Wholesale Distributors
Thompson's Pet. Inc

Memorandum from Department of Building Inspection, Portland, Maine

Thompson's Point--Installation of mechanical ventilation system in office building for Utilities Distributors, Inc. by W. B. Bourne & Son, installers--1/18/49

CITY OF PORTLAND.....DEPT. OF BUILDING INSPECTION

**THOMPSON'S POINT
 PROPERTY
 PLOT PLAN**

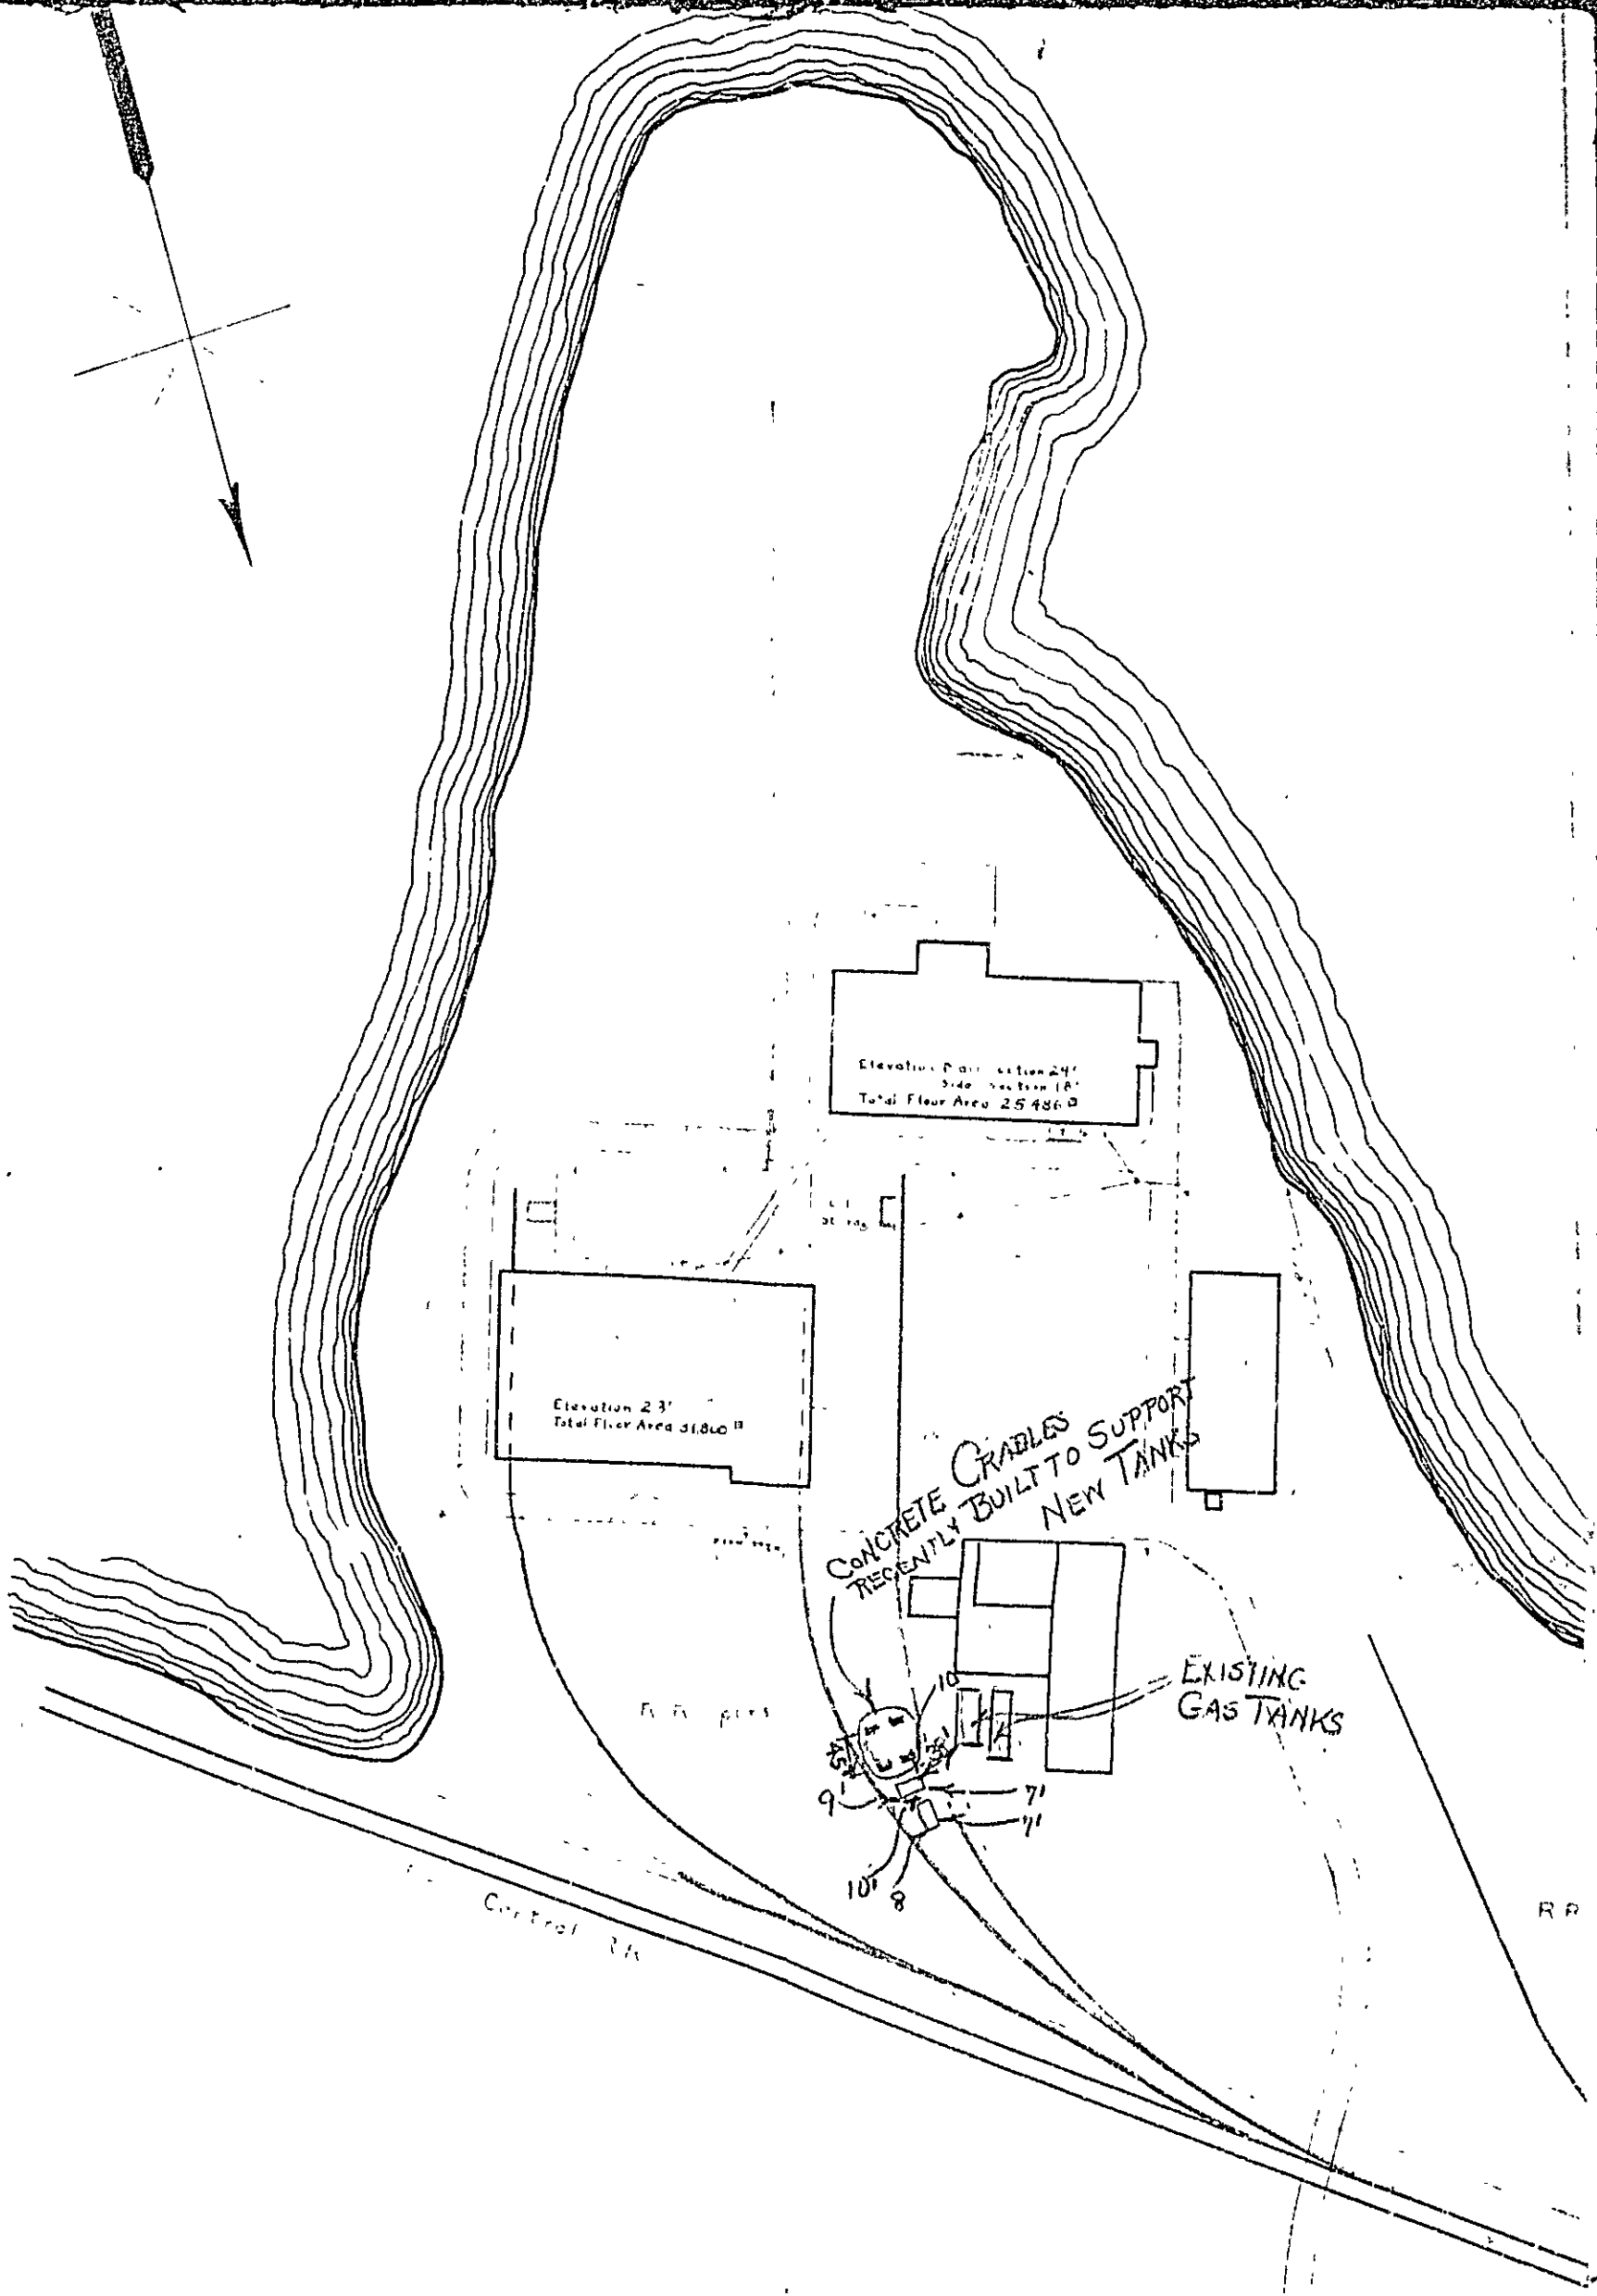
WMed/S
P.S. Permit issued December 1, 1946 based on Location Plan 197 and Design
Plan BR-22, both received here 12/4/46, and Plan SK-9 with letter by E. S. Colburn
and statement of design by C. W. Ginn received 12/11/46.
As agreed with Mr. Anderson I am assuming that Mr. Ginn's statement of design
covers the design of the tank as a self-supporting beam. If this is not the case, please
refrain from erecting the tank until a statement of design is furnished by someone who
does take the responsibility for the design of the tank. I am well aware that the
large diameter tank will have a very large section modulus, but in view of the serious
consequences of failure, it is my duty to see to it that the line of responsibility is
clear. In case of a former smaller tank, you had the manufacturer sign for that re-
sponsibility, but, as explained to Mr. Anderson, we have no objection if your designer
is assuming it.

Also I take it that Mr. Ginn's statement covers the design of foundations and
the added reinforcement indicated in Mr. Colburn's letter. In this connection, I
assume the statement as to footing reinforcement means that the bars are to be run
parallel to the shorter cross-sectional dimension of the pier above. Bars are indi-
cated to be in center of footing. Greater strength would obtain if bars were placed
about 2 inches above bottom of footing.
